Work Order ID 84542

Item Name: Cabin Floor Protector (Black)

DART SERVICE INSTRUCTION

TO AMEND INSTALLATION INSTRUCTIONS IIN-D044-719 REV. A
AND INSTRUCTIONS FOR CONTINUED AIRWORTHINESS ICA-D044-719 REV. 0

D3281-1 FLOOR PROTECTOR

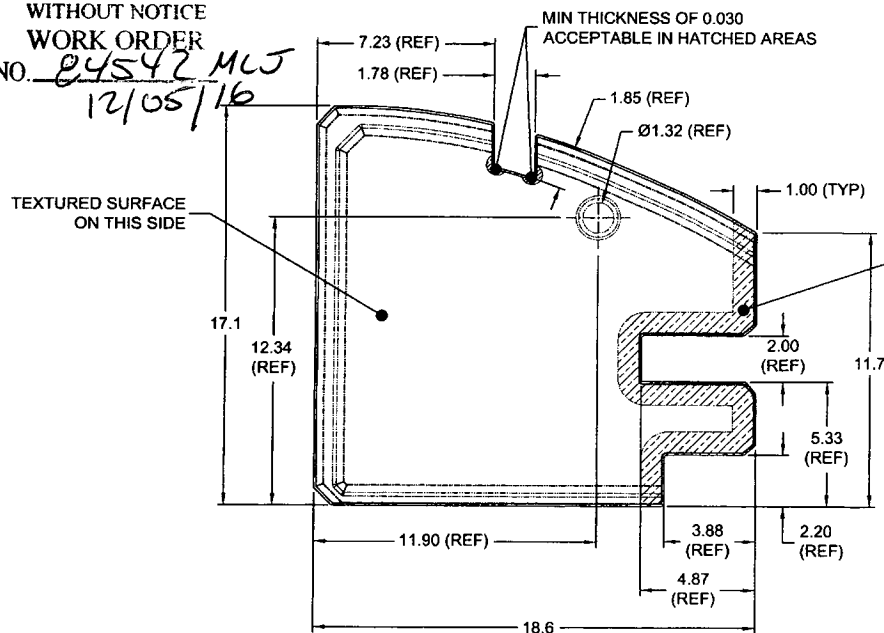
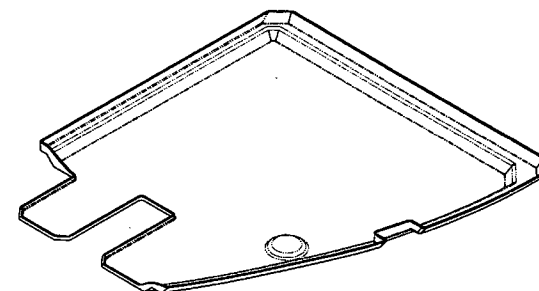
F	NOTES UPDATED. FLAG NOTE 6 WAS 7 & RELOC, D.E.O. D3281-E-1 INC. DIM 17.0 WAS 17.1 (ZN B5-3, B6-4) & 17.7 WAS 17.8 (ZN C5-3, C6-4) REF CAR 10-21.	JPH	10.09.27
E	-3/4 NOW TRIMMED FLAT; RMV 0.25 BEVEL TO FACILITATE TRIMMING (ZN D6-3, D4-4)	CP	10.01.05
D	THICKNESS 0.093 WAS 0.125, MIN THICKNESS 0.070 WAS 0.080, P/N AND B/N ID WITH VIBRATING STYLUS (ZN A7-1, A7-2, A7-3, A7-4); D3281-4 NOW ON PAGE 4; CORRECT WEIGHTS (ZN A8-1, A8-2, A8-3, A8-4)	PH	08.03.28
C	UPDATE DIMS TO MATCH PARTS: COLOUR 701 WAS 700; GENERAL UPDATE	LE	07.10.09
B	NOW LEXAN; DIMS AS MANUFACTURED	CP	05.11.25
A	NEW ISSUE	CP	04.05.03
REV.	DESCRIPTION	BY	DATE
DESIGN			
DRAWN			
CHECKED			
MFG. APPR.			
APPROVED			
DE APPR.			
DATE	10.09.27		
DART AEROSPACE LTD HAWKESBURY, ONTARIO, CANADA
